May 4, 2004

Subject: Duke Energy Corporation
Catawba Nuclear Station, Unit 1
Docket Number 50-413
Steam Generator Outage Summary Report for End of Cycle
14 Refueling Outage
Reply to Request for Additional Information
(TAC Number MC1703)

REQUEST FOR ADDITIONAL INFORMATION

CATAWBA NUCLEAR STATION, UNIT 1

**Attachment 1
CFR 80 Steam Generators**

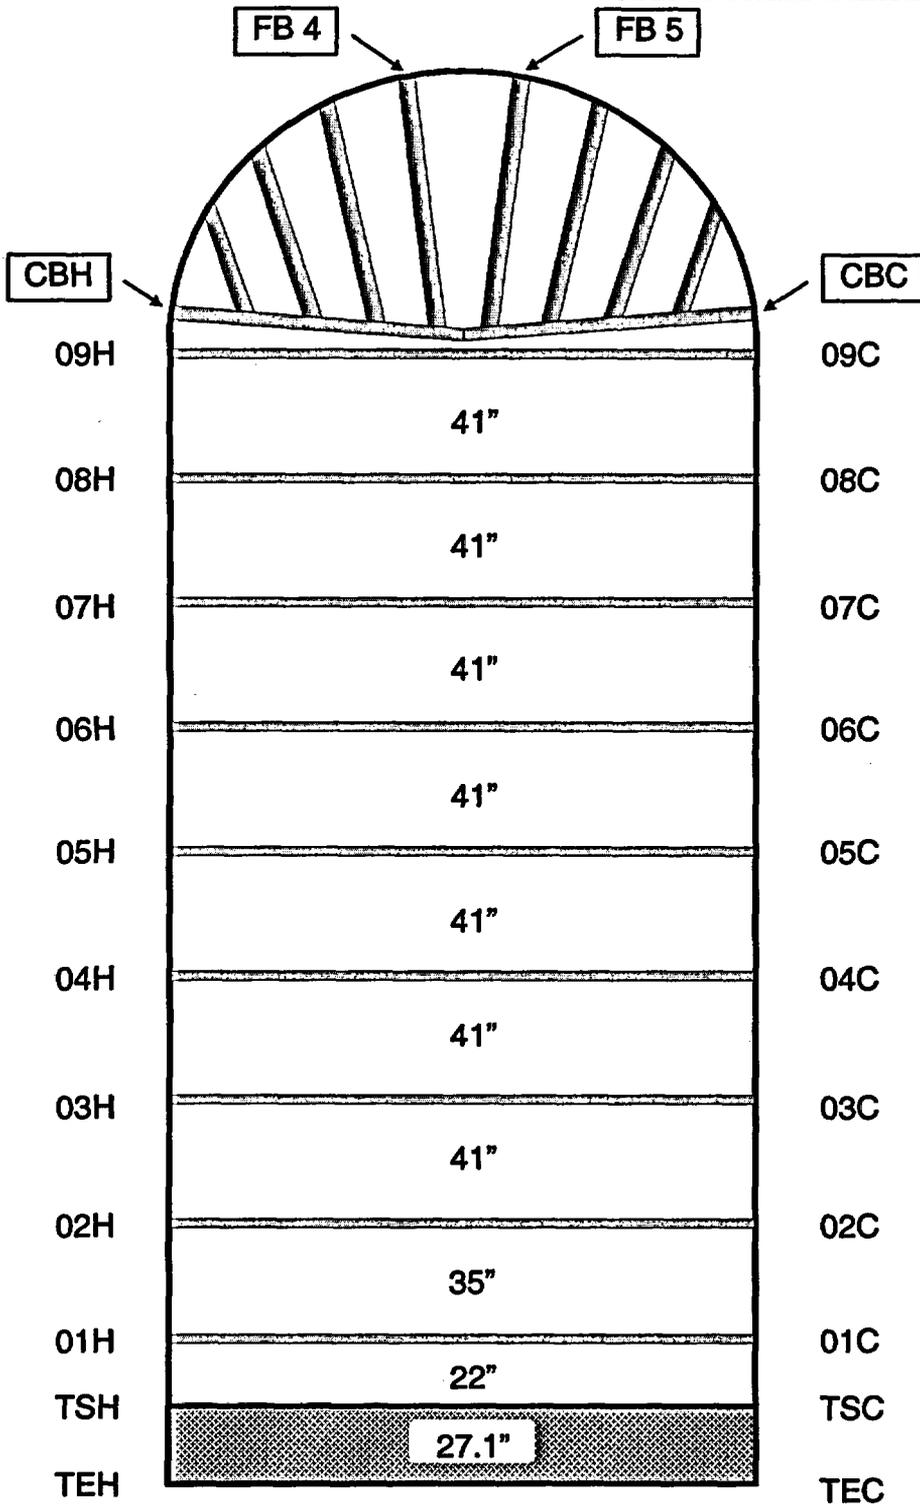
1. The steam generators at Catawba, Unit 1, were replaced in 1996 with Babcock and Wilcox International CFR 80 steam generators. In several locations in your reports, you reference tube support structures (e.g., fan bar 4) and tube locations (e.g., Row 14 Column 55). In order for the NRC staff to better understand the location of the indications, please provide (1) a sketch of the Unit 1 steam generators which depicts the tube support naming conventions and (2) a tubesheet map which depict the rows and columns of the tubes. In addition, please provide the following general design information: tube manufacturer, tube material, tube outside diameter, tube wall thickness, tube support (including fan bar/anti-vibration bar) material and configuration, tube support (including fan bar) thickness, tube pitch and orientation (e.g., 1.1-inch triangular pitch), expansion method, and any other noteworthy design characteristics from a steam generator tube integrity standpoint (e.g., full length stress relief of the row 1 through row 10 tubes). Furthermore, discuss whether measurements from a tube support are from the middle of the support or the edge of the support. For example, does fan bar 5 minus 0.9 inches specify an indication 0.9 inches from the bottom edge of the fan bar?

Attachment 1 is a sketch of the Unit 1 steam generators which depicts the tube support naming conventions and Attachment 2 is a tubesheet map which depicts the rows and columns of the tubes. Attachment 3 is the rotating coil characterization codes. Attachment 4 is the bobbin coil characterization codes.

Positive direction is physically upwards in the steam generator with the positive direction stopping at the apex of the U-bend. Measurements should be made using the nearest available landmark. All measurements should be referenced from the center of a landmark. Measurements may be made in a positive or negative direction using the nearest available landmark.
